ATTACHMENT D

Marked-Up Current Technical Specification Pages

DRESDEN II DPR-19
Amendment No. 34, 82, 101, 107

FIGURE 4.8-1

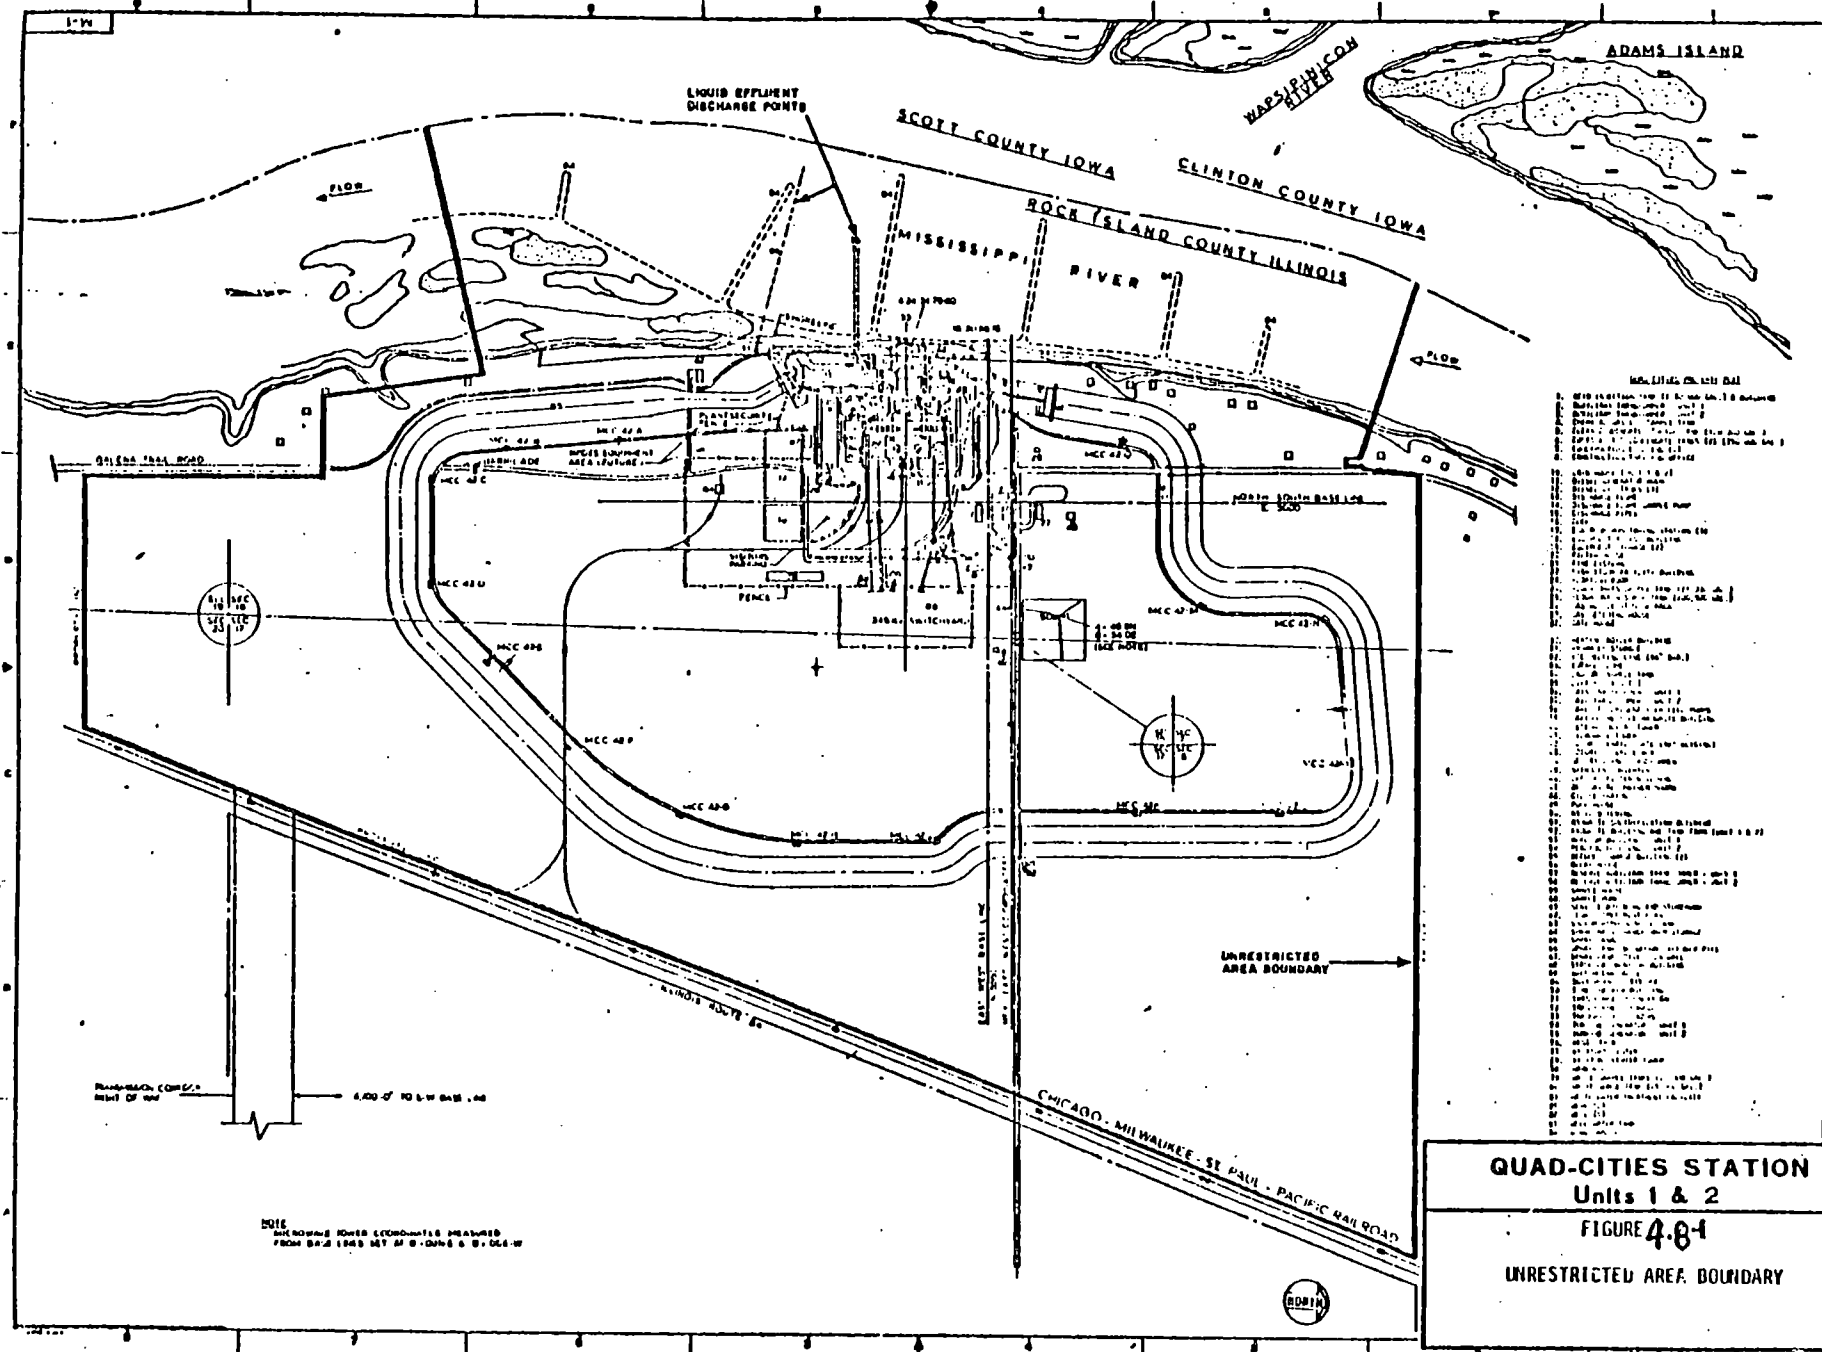
RELOCATED
